# Service Bulletin № 74

SEGA
PINBALL, INC.

RE: Modification to *BAYWATCH* Early Production Games

Fig. 1

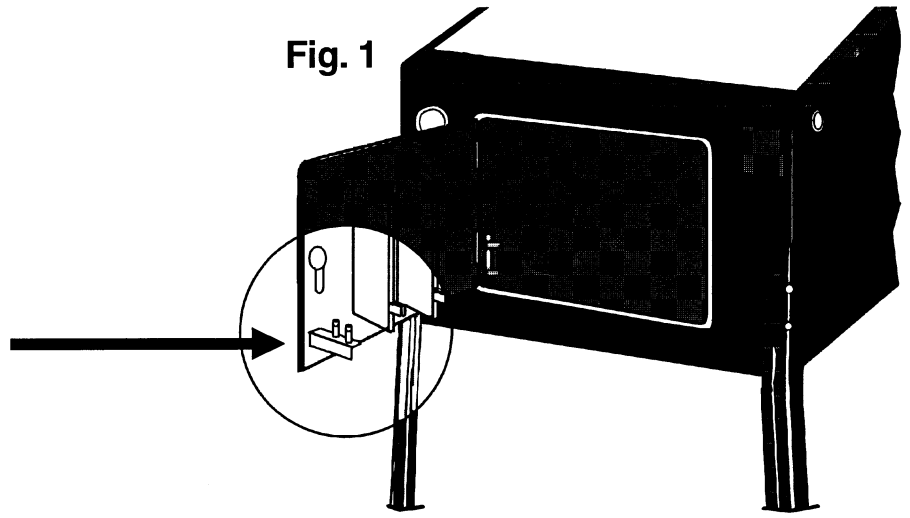
Step 1
Open the Coin Door and locate the Service Switch Set Bracket & Coin Door Mounting Bracket. (See Fig. 1)

Fig. 2

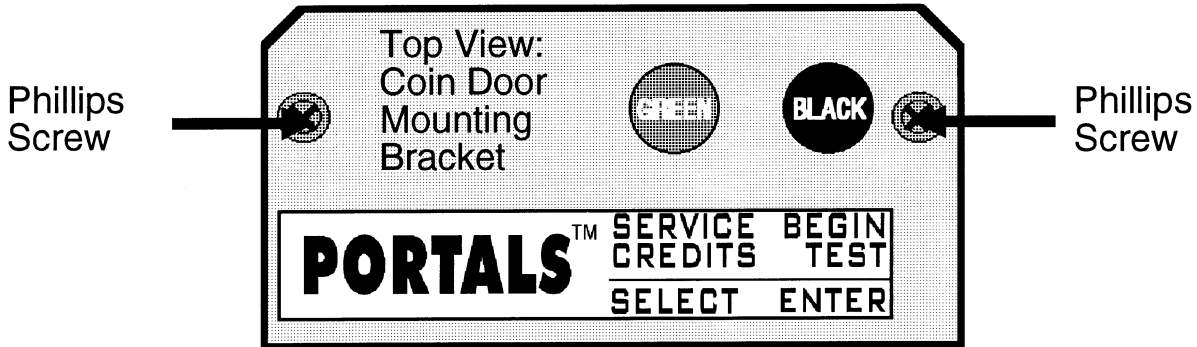
Step 2
Remove the 2 Phillips Screws securing the Switch Set Bracket to the Coin Door Bracket. (See Fig. 2)

Fig. 3

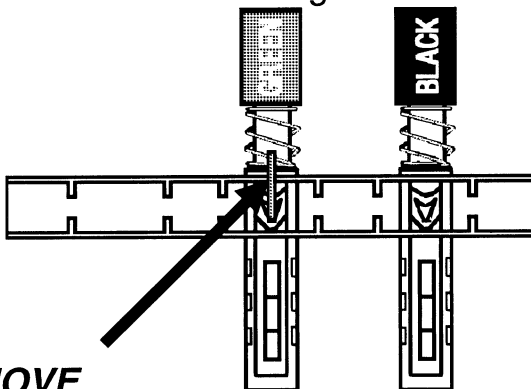
Step 3
The Switch Bracket will now be separated from the Coin Door Bracket still attached by the wires. (See Fig. 3)

Step 4
Locate the Green Button Switch. Remove the silver "C" shape wire form from the switch. The switch is now a "non-interlocking" Momentary Switch. (See Fig. 3 & 4)

REMOVE
Silver "C" Shape Wire Form

Fig. 4

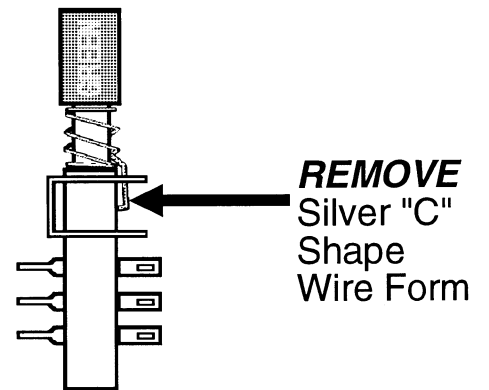
REMOVE
Silver "C" Shape Wire Form
